Pre-Application Report

Case Number / AMANDA No. PRE-AP22-67 / 22-111188-PA
Conference Date June 13, 2022
Applicant THOMAS ELDRIDGE
126 NE ALBERTA ST STE 202
PORTLAND OR 97211
Representative DAVE MOJICA
2525 E BURNSIDE ST
PORTLAND, OR 97214
dmojica@seallp.com
BEN SCHONBERGER
610 SW ALDER ST STE 810
PORTLAND, OR 97205
ben@winterbrookplanning.com
Case Manager Brandon Pike

Planning Division Comments

SITE PLAN

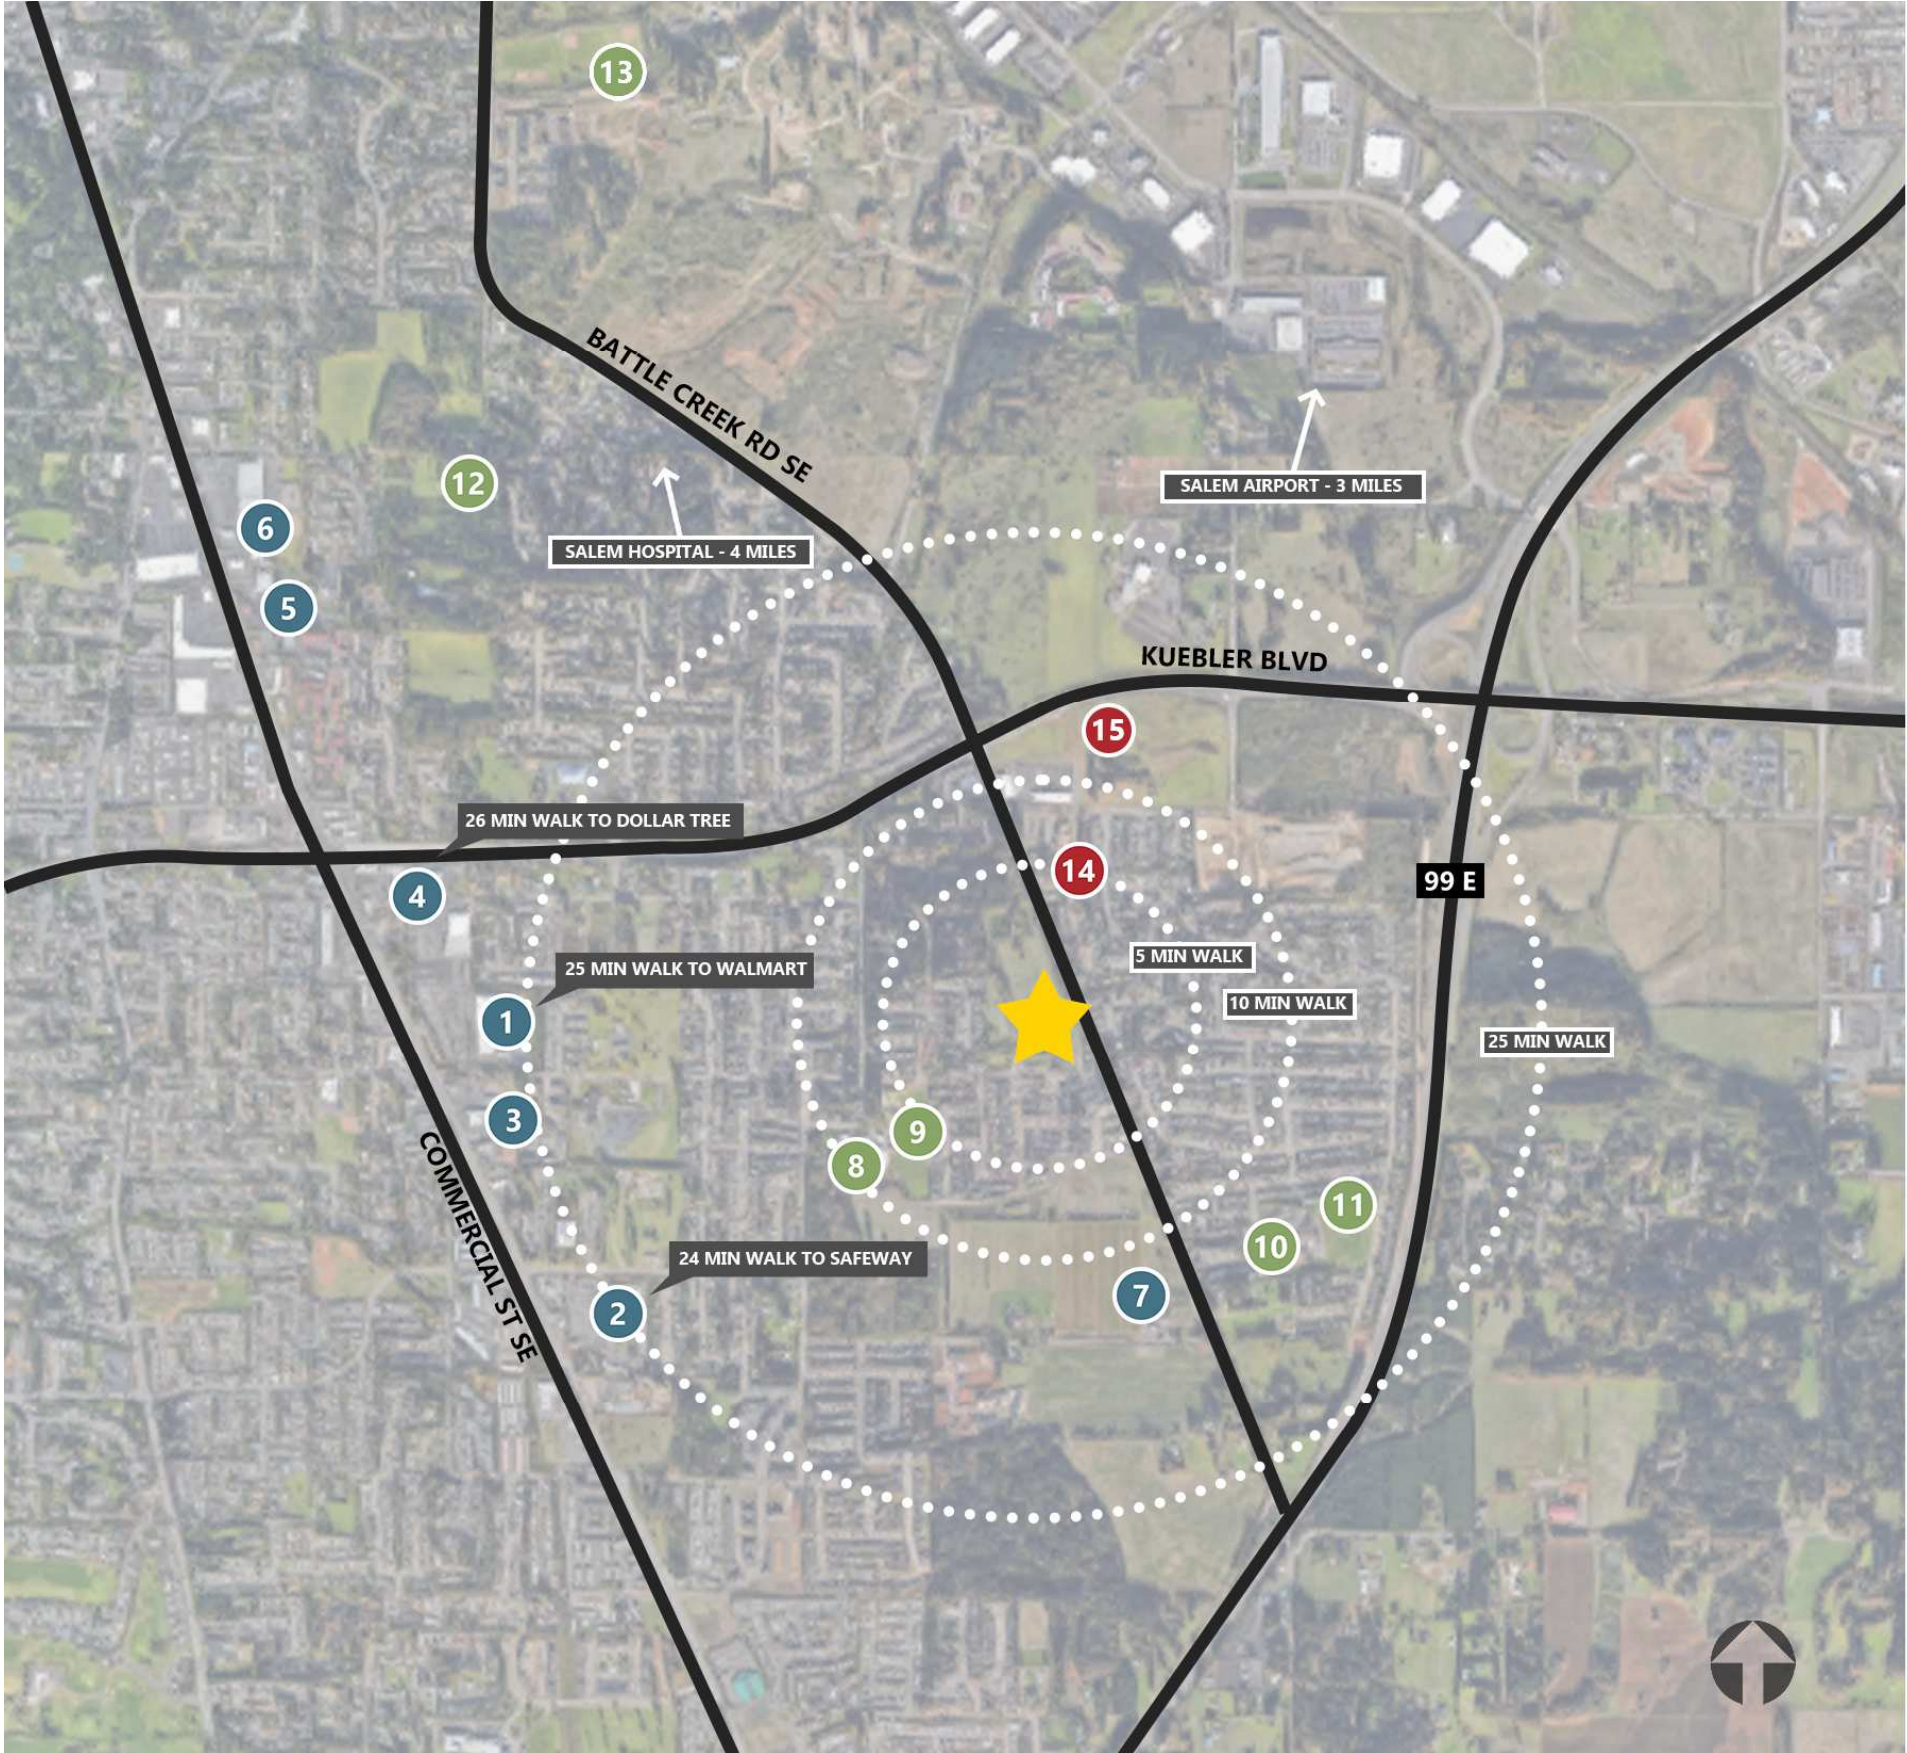
- **SRC 702.020(a)(1)(B):** *To ensure the provided open space is usable, a maximum of 15 percent of the common open space shall be located on land with slopes greater than 25 percent.* Not clear if this is met without topography shown.

- **SRC 702.020(b)(2):** *Landscaping and screening abutting property zoned RS. Where a development site abuts property that is zoned Residential Agricultural (RA) or Single Family Residential (RS), a combination of landscaping and screening shall be provided to buffer between the multiple family development and the abutting RA or RS zoned property. The landscaping and screening shall include the following: (A) **A minimum of one tree, not less than 1.5 inches in caliper, for every 30 linear feet of abutting property width;** and (B) **A minimum six-foot tall, decorative, sight-obscuring fence or wall.** The fence or wall shall be constructed of materials commonly used in the construction of fences and walls, such as wood, stone, rock, brick, or other durable materials. Chainlink fencing with slats shall be not allowed to satisfy this standard.* This will be required along the western property lines.

- **SRC 702.020(e)(2):** *Where a development site abuts property zoned Residential Agricultural (RA) or Single Family Residential (RS), buildings shall be setback from the abutting RA or RS zoned property as set forth in Table 702-5 to provide appropriate transitions between new buildings and structures on site and existing buildings and structures on abutting sites.* The proposed buildings appear to range between 35 and 37 feet in average height, requiring greater setbacks to the western property lines than what is shown for many of the buildings.

- Not met on Salal Street side. Staff would expect buildings 3 and 7 (or similar) to be rotated and oriented toward Salal Street.
 - Building 6 does not appear to be placed at 20-foot setback line, and would need to be shifted closer to Teal Drive.

- **SRC 702.020(e)(5):** *To orient buildings to the street, any ground-level unit, cluster of units, interior lobbies, or portions thereof, located within 25 feet of the property line abutting a street shall have a building entrance facing that street, with direct pedestrian access to adjacent sidewalks.* Buildings 5 and 6 need direct connections between the units and the adjacent street.

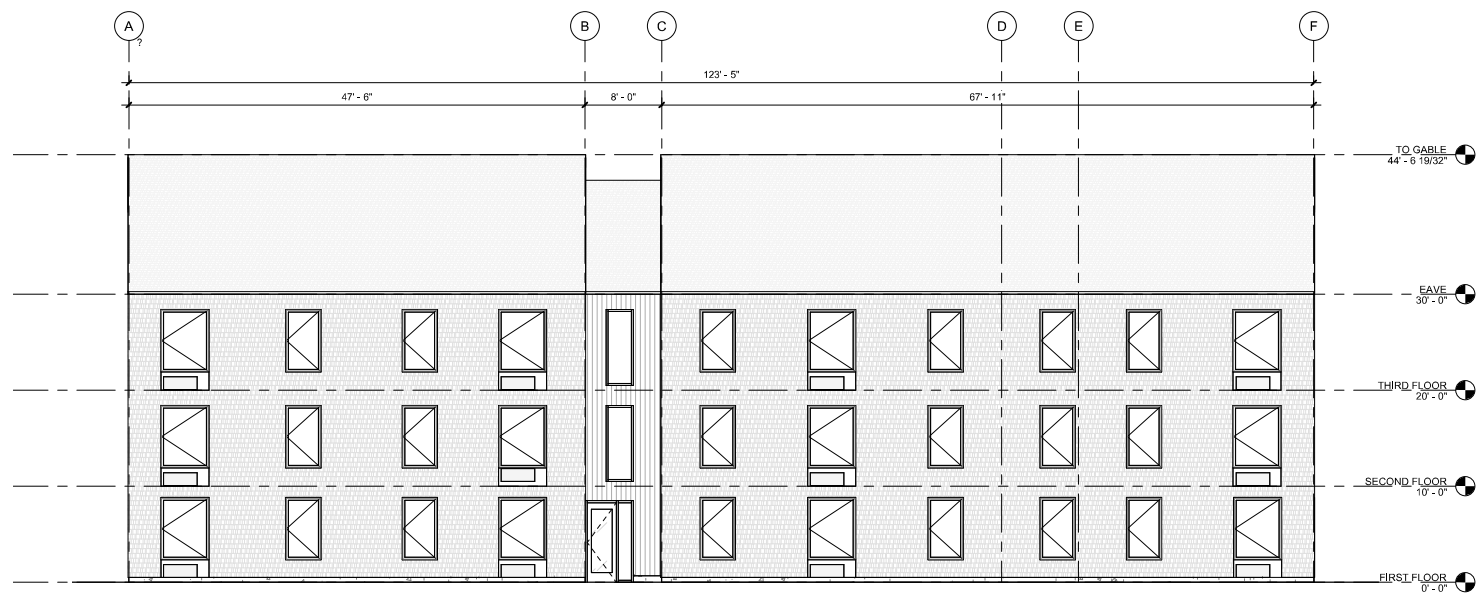
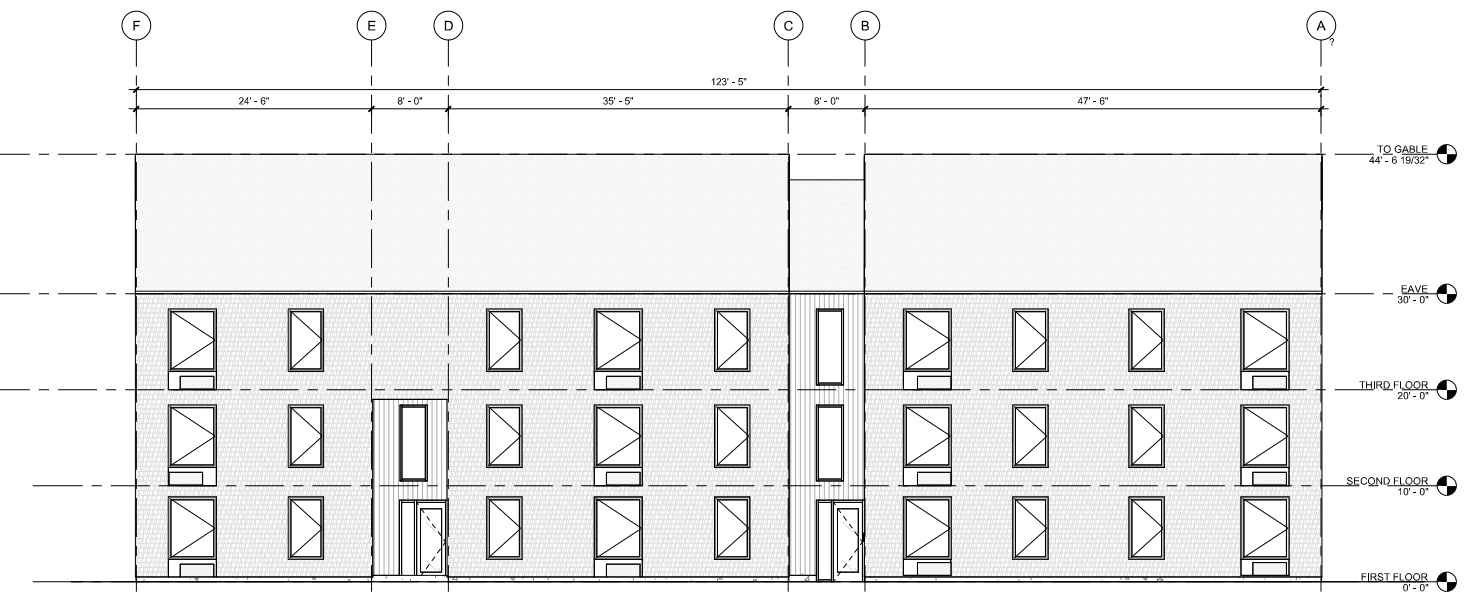
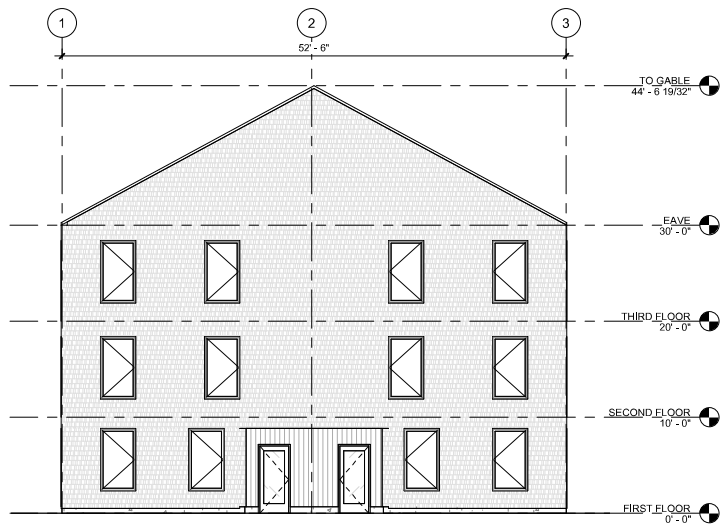
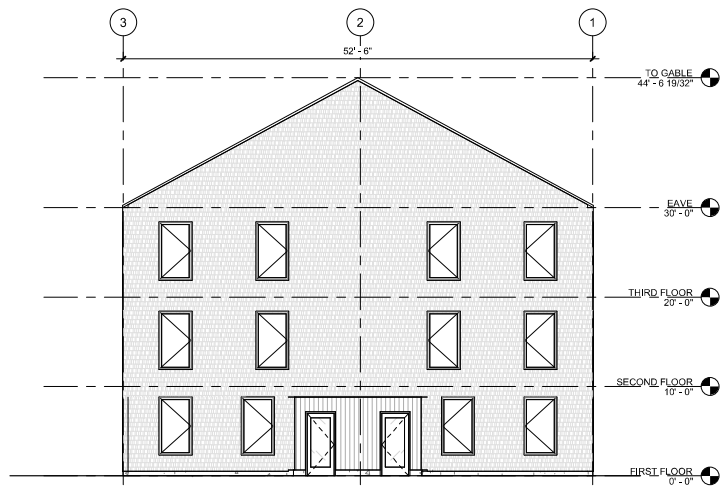
- **SRC 702.020(e)(10):** To visually break up the building's vertical mass, the first floor of each building, except for single-story buildings, shall be distinguished from its upper floors by at least one of the following (see examples in Figure 702-6): (A) Change in materials. (B) Change in color. (C) Molding or other horizontally-distinguishing transition piece. This standard does not appear to be met on buildings G1 and G2.
